US 301 (CRAIN HWY) AND MITCHELL ROAD

LAPLATA, MARYLAND

TRAFFIC SIGNAL PLAN

TS NO. 2112B | DRAWING NO. 1 OF 2 | SHEET NO. OF

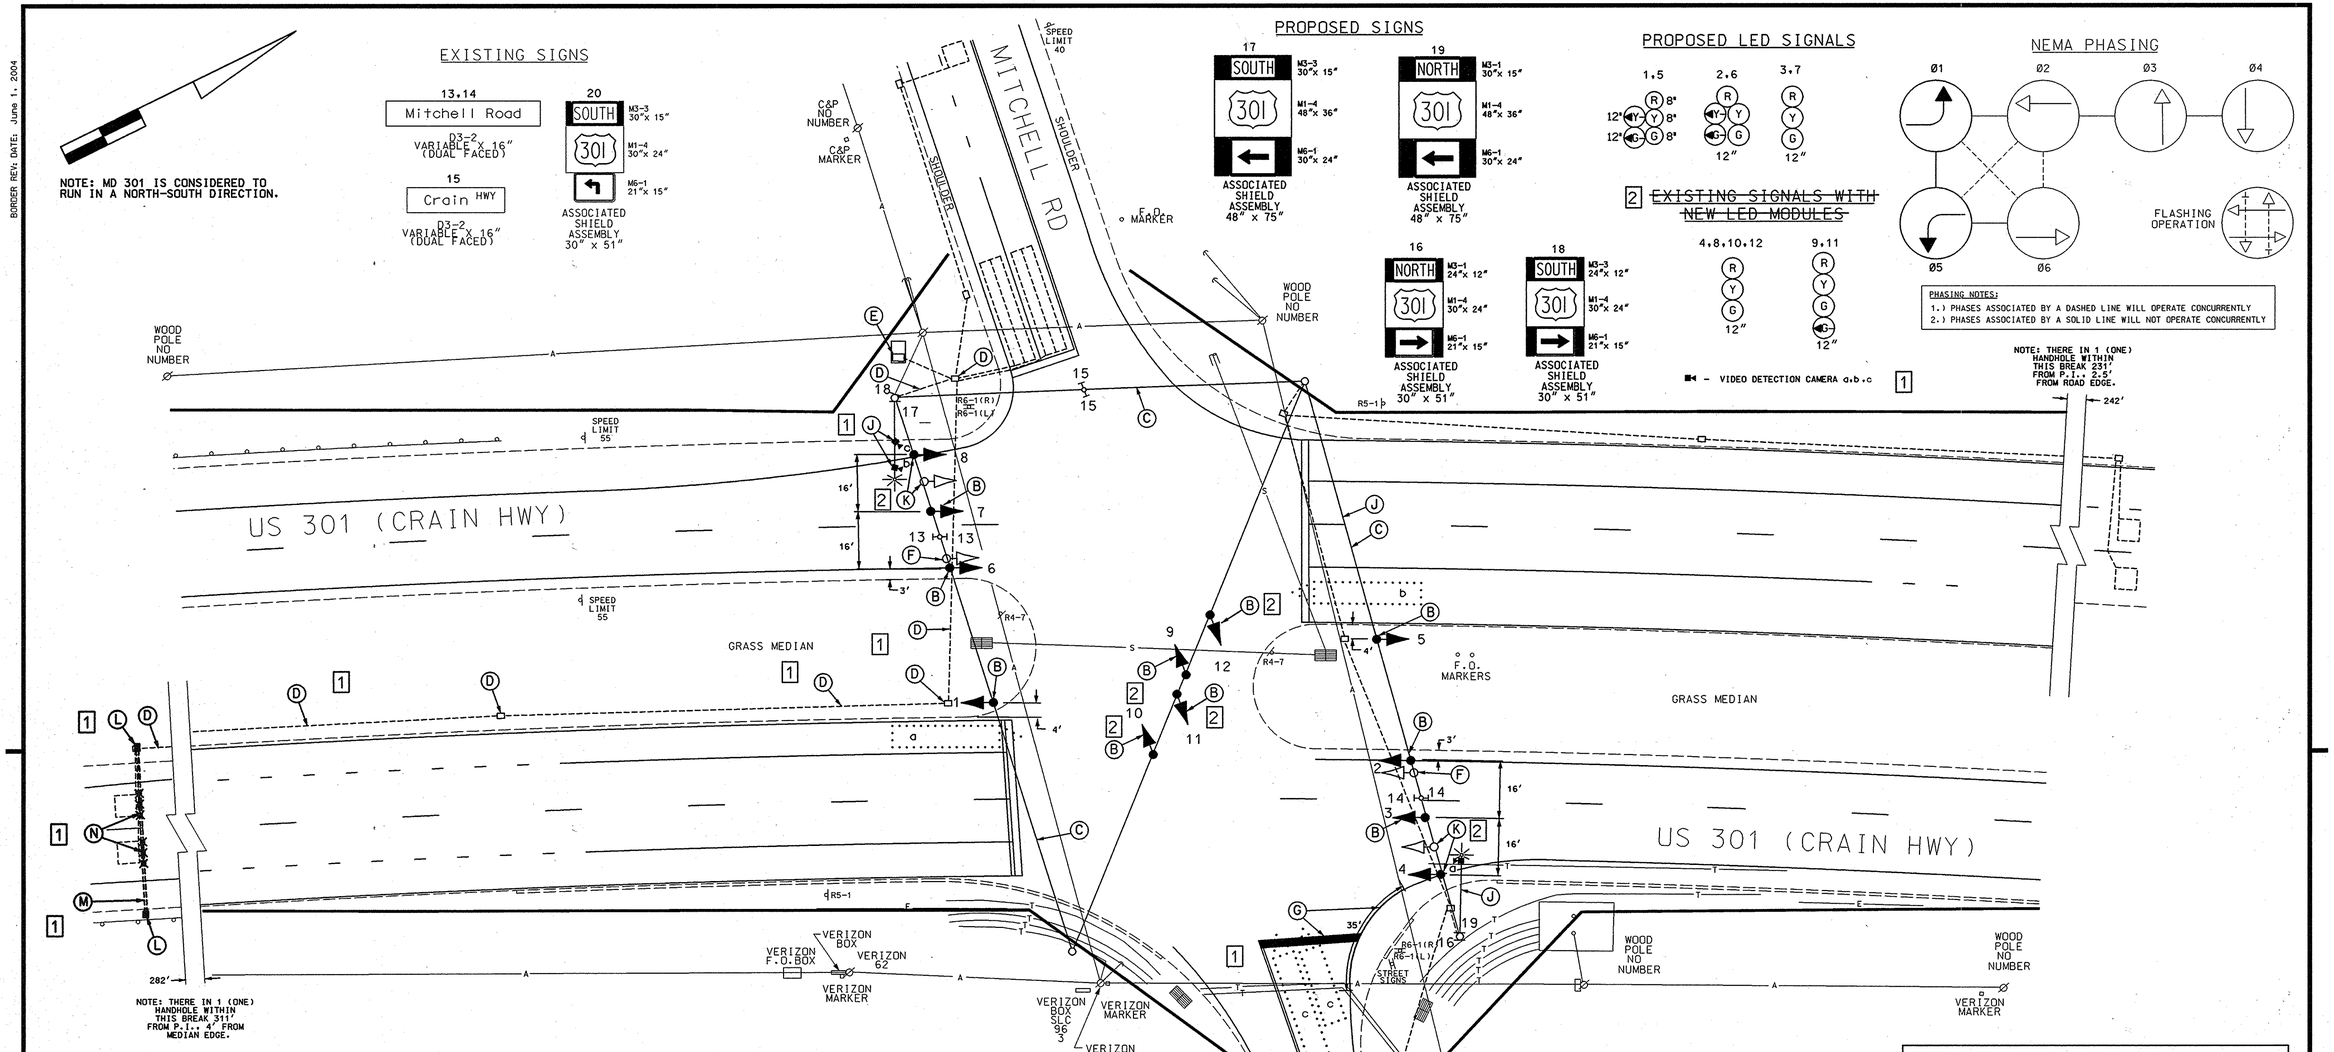
2 ~~EXISTING SIGNALS WITH NEW LED MODULES~~

2 ~~A. Install LED Modules in existing Signal head as shown.~~

2 K. ~~Relocate~~ Remove existing signal head ~~to proposed location as shown~~ and install LED ~~modules into~~ signal head as shown.

1 REDLINE REVISION 8/6/08
TEDD APPROVAL _____

2 REDLINE REVISION 10/31/08
TEDD APPROVAL _____ 11/10/08
